Staff Report

Re: PLNHLC2017-00722 – Modifications to Certificate of Appropriateness for New Construction Approval

Appeal of Historic Landmark Commission Decision

PROPERTY ADDRESS: 613 East 100 South

1. Modifications to the South (Front) Façade

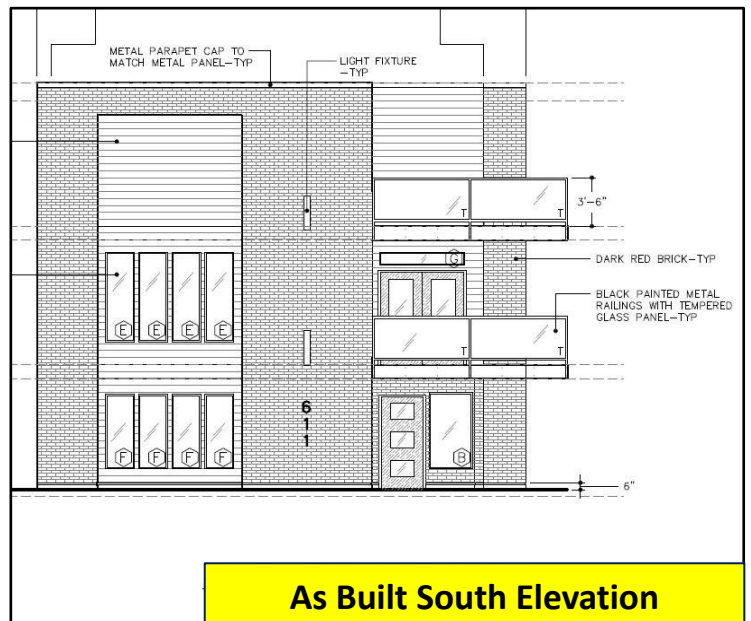
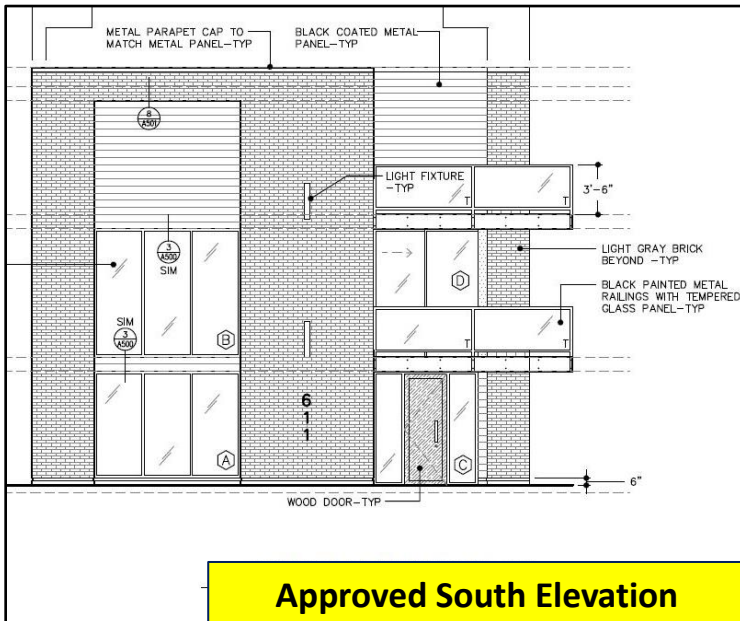
- The two rows of windows on the left building plane have changed in configuration and dimension from a tripartite arrangement (10’4”w x 7’6”- 9’h) to four smaller side-by-side vertically emphasized fixed casement windows (8’6”w x 5’5” - 6’6”h total).
- All of the window material has changed from fiberglass to vinyl

2. Modifications to the East (Interior) Façade

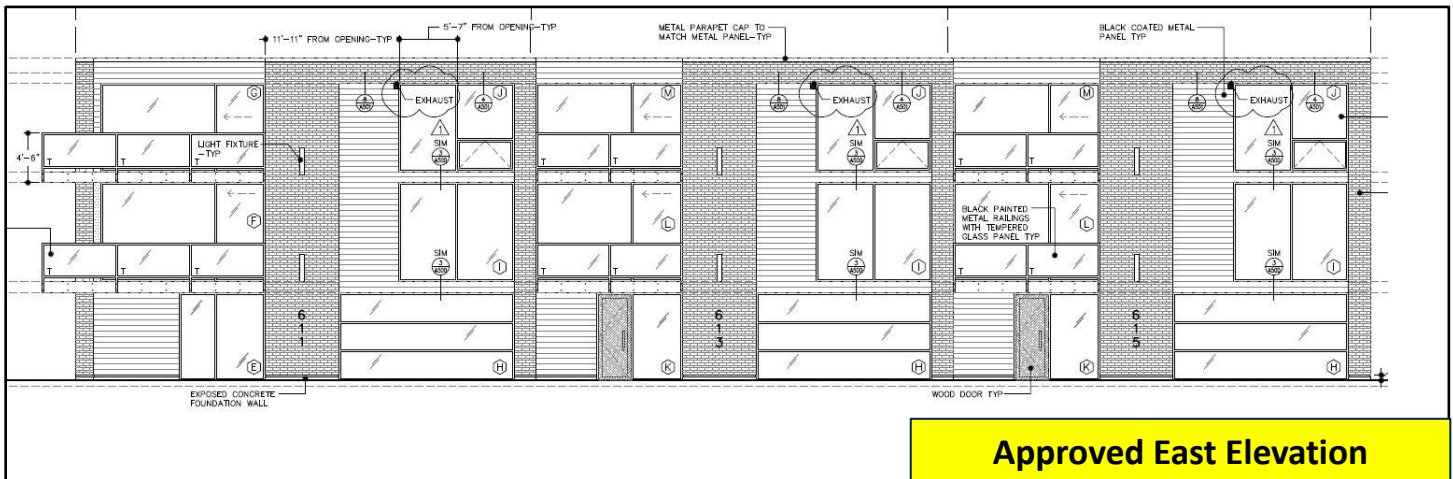
- Recessed building planes - The window/sliding door configuration off of the second and third-level balconies have changed in configuration and dimension to 3-5 side-by-side vertically emphasized casement windows
- Forward building planes - The window arrangements on the three building planes above the garage doors have changed in configuration and dimensions to four side-by-side vertically emphasized casement windows
 - Second level opening changed from 10'6" w x 9' h to 8'6" w x 6'6" h total
 - Third level opening changed from 10'6" w x 8' to 8'6" w x 5'5" total
- The windows beside the two front doors are smaller in height width
- All of the window material has changed from fiberglass to vinyl

The east façade is, however, still very well articulated. Every other building plane is recessed by three feet, which works to break up this longer building wall. As each ground entry is recessed, the doorways are not very visible from the public way. Therefore, staff concludes that

reconfiguring the front doorway design would not be detrimental to the character of the rest of the building and is recommending approval of this modification as seen on the as built drawings. Similarly, the change in garage door material from glass panel to steel panel would not greatly affect the overall character of the building, which is why staff is also recommending approval of this additional request.

3. Modifications to the West (Interior) Façade

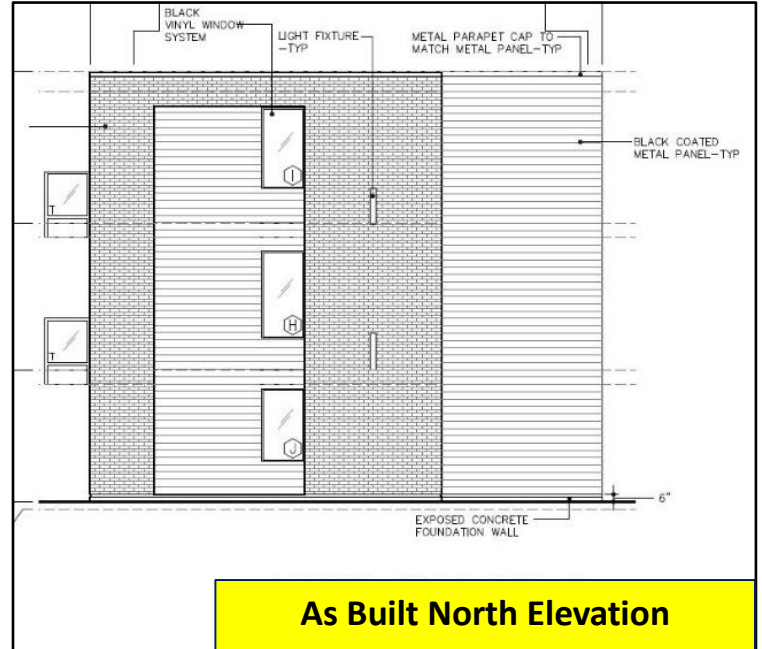
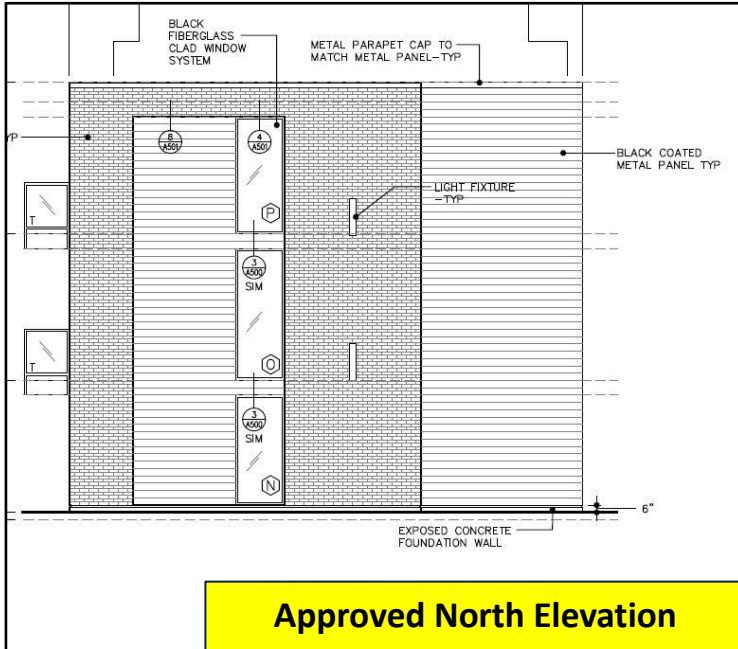
The amount of glass on this west façade has been significantly reduced from the original proposal creating an unbalanced solid to void ratio. This may be more apparent on this façade as it is not as well articulated as the east. The relationship of the width to the height of the windows is not visually compatible with the surrounding structures on the streetscape, which is something that the historic new construction standards require. Because of these reasons, staff is recommending denial of the request to modify the windows on the second and third floor of the building. However, as the back doorways are recessed and not very visible from the public way, staff concludes that reconfiguring the back doorway design would not be detrimental to the character of the rest of the building and is recommending approval of these modifications as proposed on the as built drawings.

- Deny the request to modify the windows on second and third floor of the west façade
- Approve the request to reconfigure the back doorway design and door material on the ground floor of all three units
